# Access Compliance Report

## Public Rights-of-Way

Intersection ID: 16680	Main Street: NORTH_FALLS_DR	Cross Street: WATER_RIDGE_PY	Location: SE
ADA ID: 536B08E80AF4	Ramp Type: PerpDiag	Initial Pass/Fail: Fail	Overall Compliance: No
Severity Score: 37.5			
Codes/Mitigation Info/Possible Solution		Field Measurements/Component Compliance

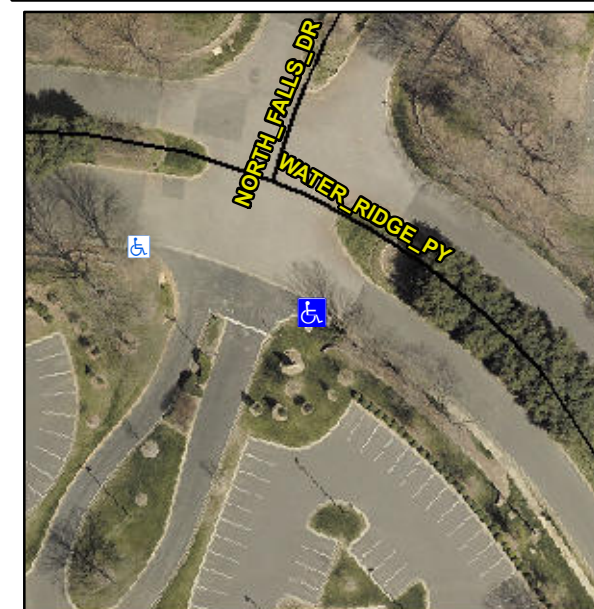
**Not Found, R304.2.2, R304.5.3**

Compliance	Description	Data	Compliance	Description	Data
N/A	Ramp Length (in)	67.0	No	Ramp Slope (%)	11.6
Yes	Ramp Width (in)	53.0	No	Ramp XSlope (%)	10.0
N/A	Flare Type LT	N/A	N/A	Flare Type RT	N/A
N/A	Flare Slope LT (%)	N/A	N/A	Flare Slope RT (%)	N/A
N/A	Flare Traversable LT?	N/A	N/A	Flare Traversable RT?	N/A
N/A	Landing Length (in)	N/A	N/A	DWS Provided?	N/A
N/A	Landing Width (in)	N/A	N/A	DWS Contrast?	N/A
N/A	Landing Slope (%)	N/A	N/A	DWS Length (in)	N/A
N/A	Landing X Slope (%)	N/A	N/A	DWS Full Width?	N/A
N/A	Landing Curb? (Y/N)	N/A	N/A	DWS Offset (in)	N/A
N/A	Shared Landing?	N/A			
N/A	Gutter Ponding?	N/A	N/A	Gutter Slope (%)	N/A
N/A	Gutter Lip Ht (in)	N/A	N/A	Gutter X Slope (%)	N/A
N/A	Painted X Walk1?	No	N/A	Painted X Walk2?	No
	X Walk 1 Direction	To N		X Walk 2 Direction	To W
N/A	X Walk 1 Width (in)	N/A	N/A	X Walk 2 Width (in)	N/A
	X Walk 1 Slope (%)	3.3		X Walk 2 Slope (%)	6.1
	X Walk 1 X Slope (%)	5.7		X Walk 2 X Slope (%)	5.0

**Remove & Replace Curb Ramp With Two New Directional Ramps or Equivalent.**
